Comments on "Adaptive Variable Structure Set-Point Control of Underactuated Robots"

Alessandro De Luca and Giuseppe Oriolo

Abstract—In this note, we point out the fallacies of a recent paper concerning the stabilization of underactuated robots.

Fig. 1. Simulation results. (a) Evolution of joint errors e_1 (—) and e_2 (- -). (b) Evolution of k .

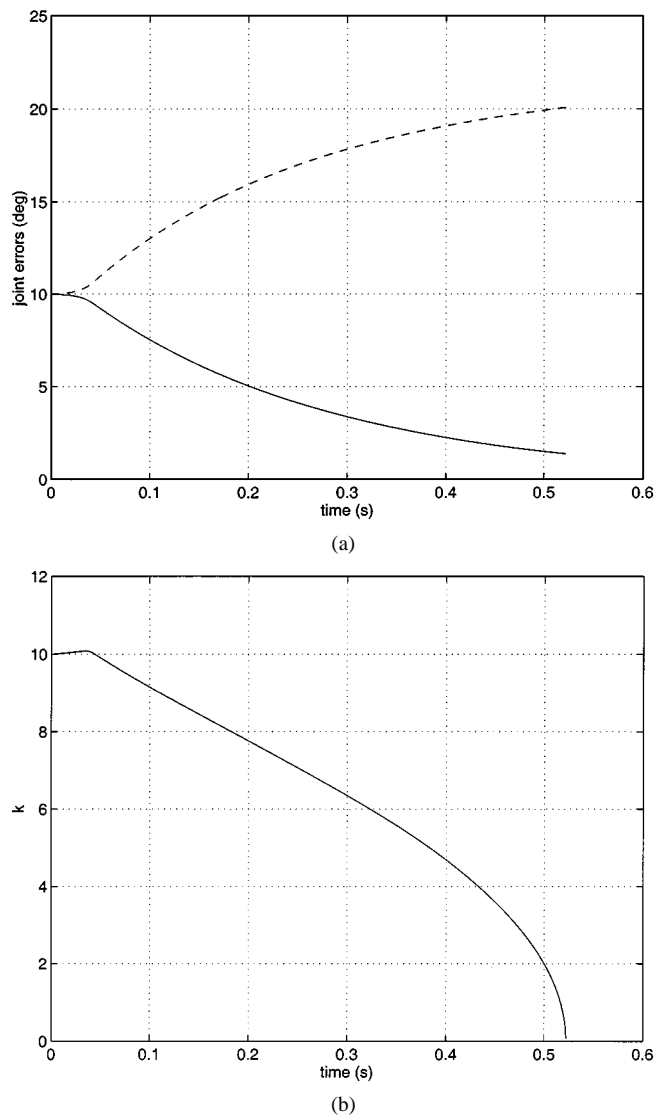
with the second term in the right-hand side clearly positive. Hence, the proof of Theorem 1 is correct unless $k(t) = 0$ at some instant t . Unfortunately, this is exactly what happens in general: k goes to zero in finite time, invalidating the proof.³ Below, we illustrate this fact analytically in a particular case and through a typical simulation result.

The above phenomenon is indeed general and clearly observed in simulations. As an example, consider a $2R$ robot with the first joint actuated, moving in the horizontal plane. The dynamic parameters are the same used in Section II of the paper. The robot is initially in equilibrium at $(q_{10}, q_{20}) = (10^\circ, 80^\circ)$ while the desired configuration is $(q_{1d}, q_{2d}) = (0^\circ, 70^\circ)$. Fig. 1 shows the results obtained by simulating the discontinuous controller (12)–(14): the first joint error goes to zero, while the second tends to increase to a constant value. Meanwhile, k is decreasing and then rapidly approaching zero, which is reached approximately at $\bar{t} = 0.53$ s. These plots suggest that the decrease of V (which is proved as long as $k \neq 0$) comes indeed from a decrease of s_a and k , while s_u grows uncontrolled. Similar results are obtained in the presence of gravity (motion in the vertical plane), as well as using the smoothed controller (24)–(26).
